ADDENDUM #3

KITSAP COUNTY PUBLIC WORKS WASTEWATER DIVISION
SILVERDALE CONVEYANCE SYSTEM AND PUMP STATION 4 UPGRADES

REF: Formal Bid Contract 2023-001

PLASTIC FOAM RING DETAIL

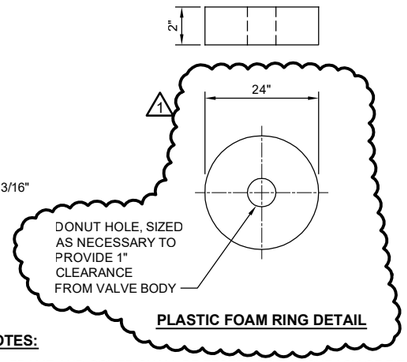
Item 6. REVISE Detail 2 on Drawing C-3: Revise the Plastic foam Ring Detail as shown on the attached Revised Drawing C-3.

AIR/VACUUM VAULT ASSEMBLY
DETAIL 1
NTS C-1A

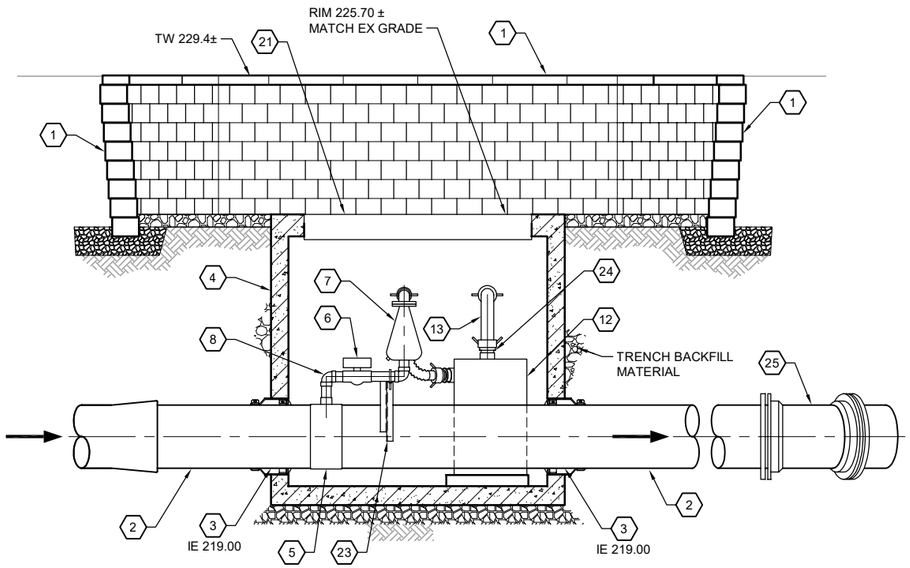
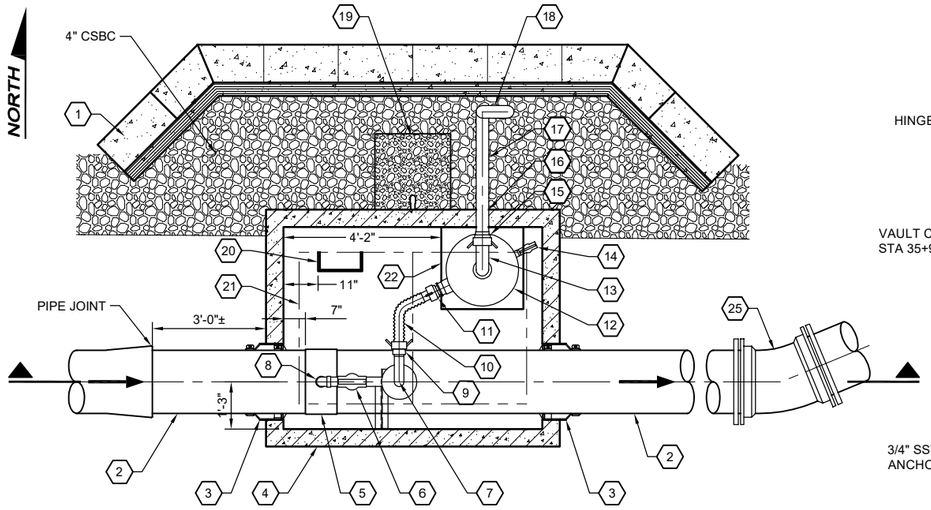
Item 7. REVISE: Air/Vacuum Vault Assembly Component #7 on Drawing C-5 is revised as follows:

~~"3" ARI D-26~~ ARI D-020 or D-025 3" Combination Air/Vacuum Valve, Threaded

5. 20" x 3" SST SERVICE SADDLE
6. 3" PVC BALL VALVE W/ 3" SCH 80 NIPPLE (PE x PE, LENGTH AS REQ'D)
7. 3" ARI D-020 OR D-025 COMBINATION AIR/VACUUM VALVE, THREADED

BYPASS CONNECTION

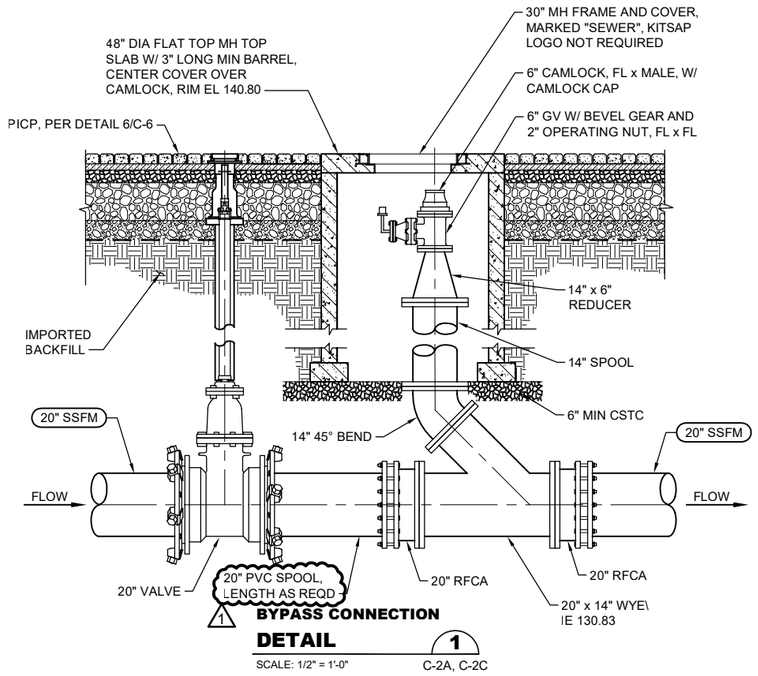
Item 8. REVISE: Revise Detail 1 Bypass Connection on Drawing C-9 to clarify that the 20" Spool between the 20" Valve and the 20" x 14" Wye shall be PVC pipe, length as required.

SITE PIPING PLAN

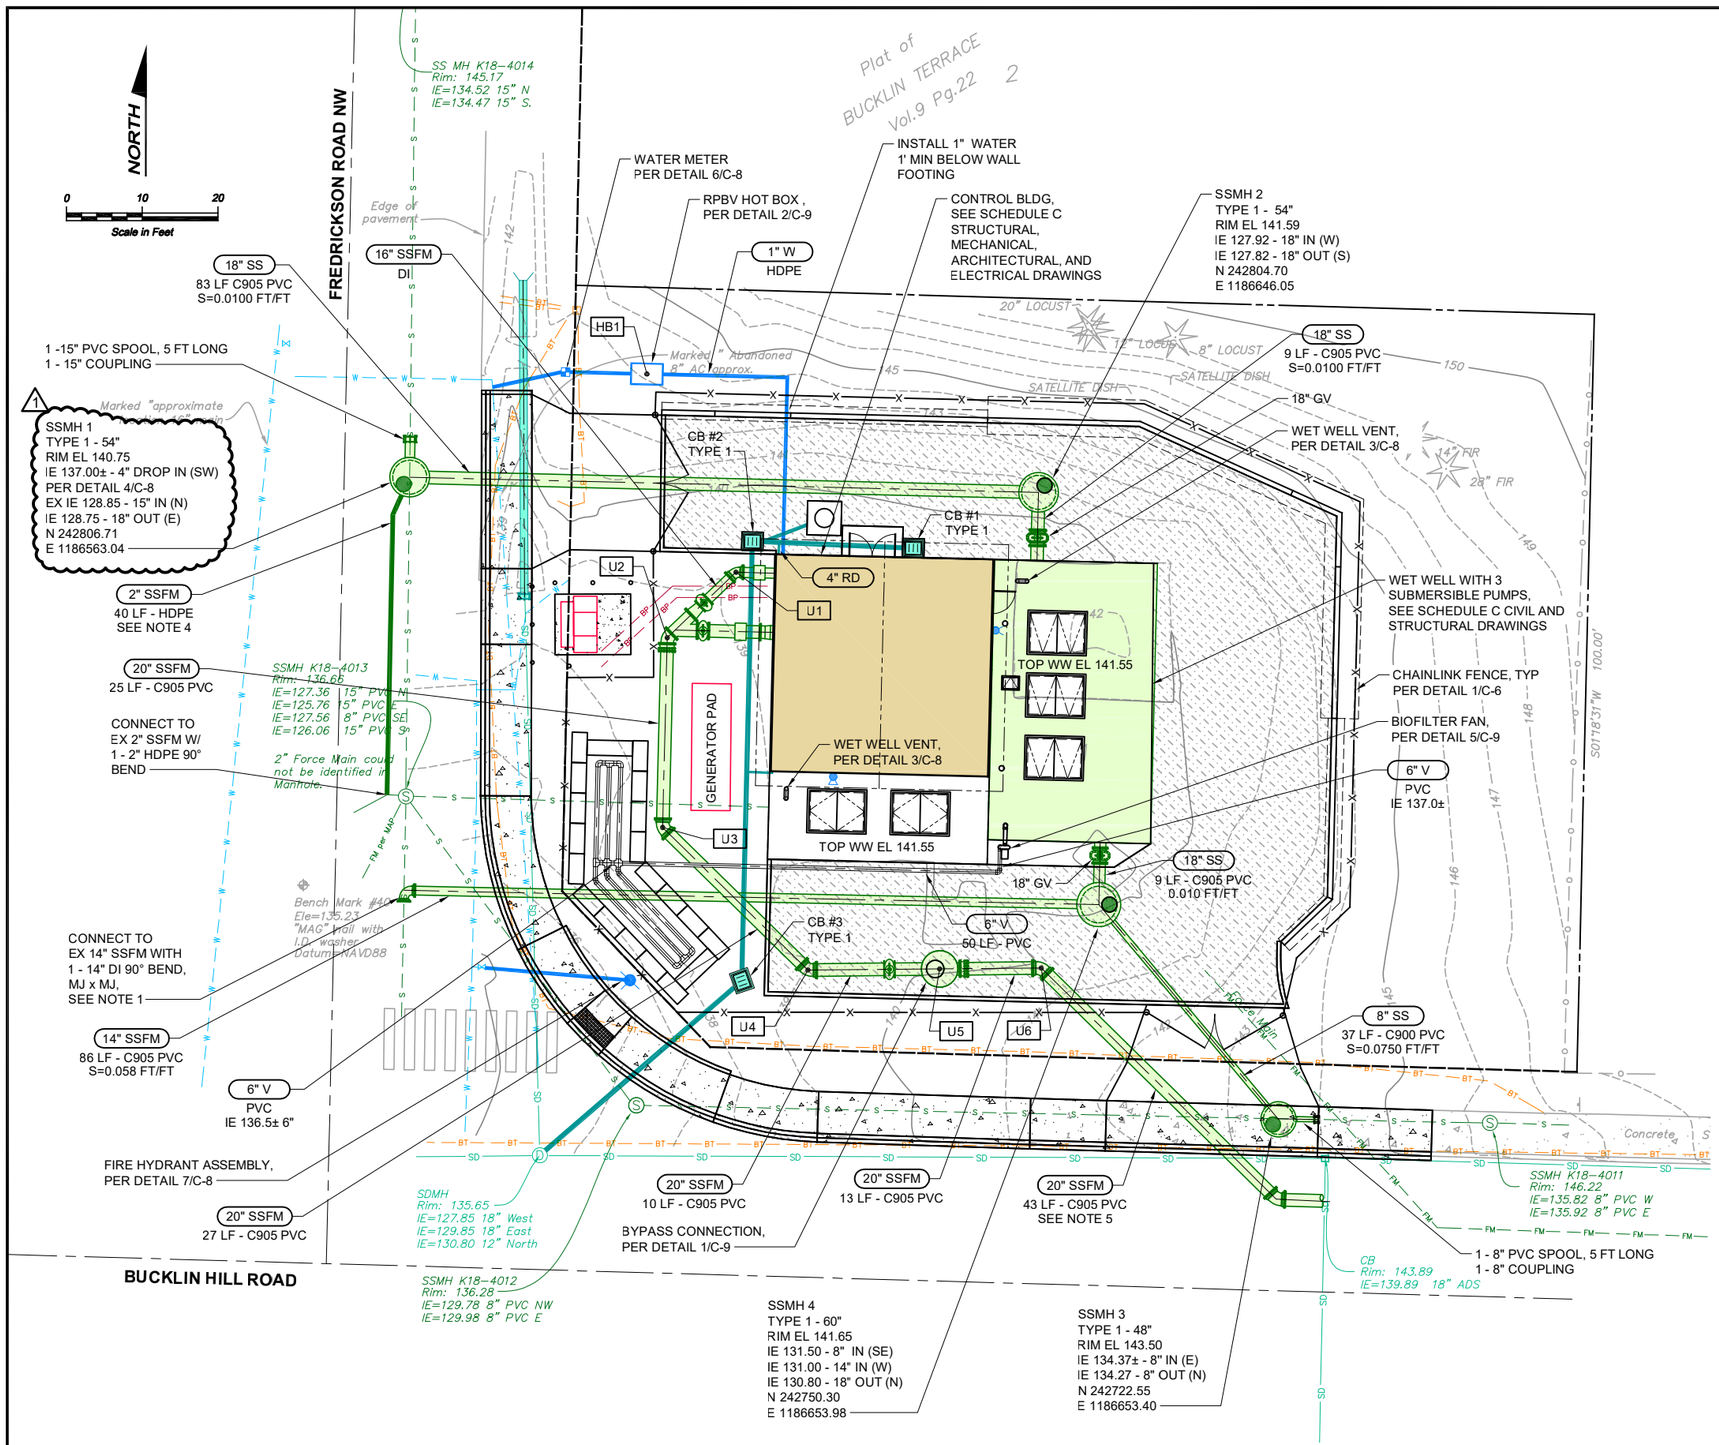
Item 10. CLARIFICATION: Note 2 on Drawing C-2C refers to all pressurized pipe on Drawing C-2C. All joints from the piping room to the 45º bend located in Bucklin Hill Road south of SSMH 3 shall be restrained since thrust blocks are not being used onsite due to space restrictions. The 45º bend located in Bucklin Hill Road south of SSMH 3 shall have a thrust block.

Item 11. REVISE: Revise the callout for SSMH as shown on the attached revised Drawing C-2C.

CONTROL BUILDING
PIPING ROOM AND WET WELL PLAN

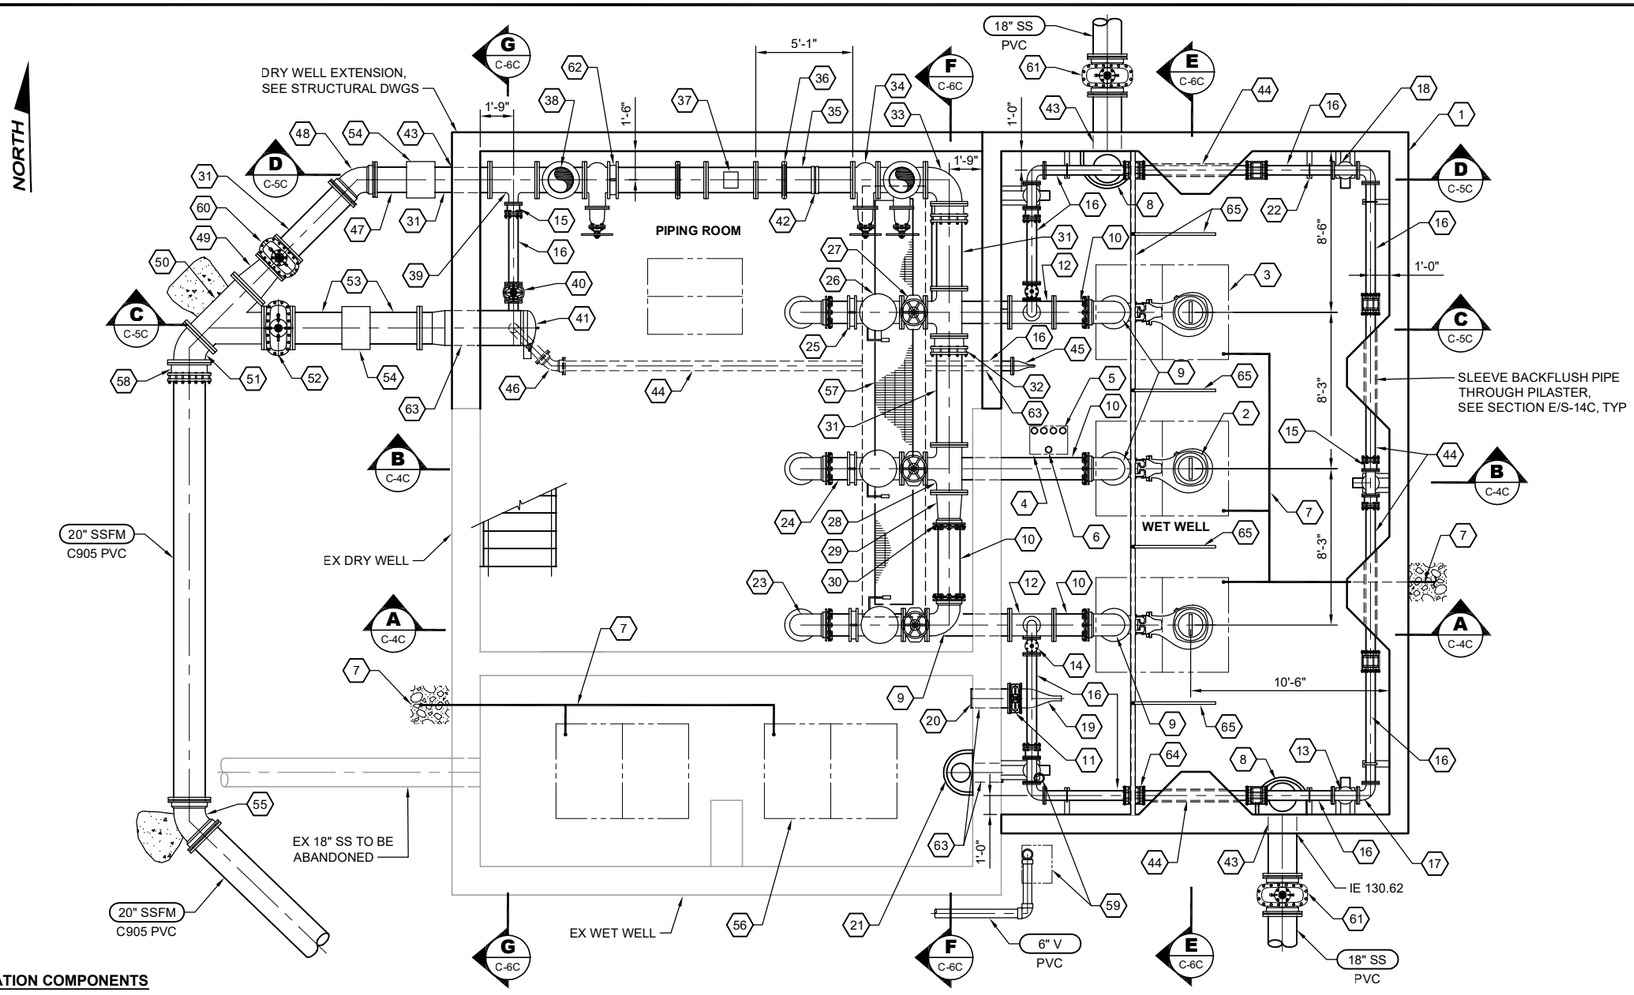
Item 12. REVISE: Pump Station Component Callout No. 11 on Drawing C-3C is revised to as follows:

"12" ~~Knife~~ Gate Valve, FL x FL
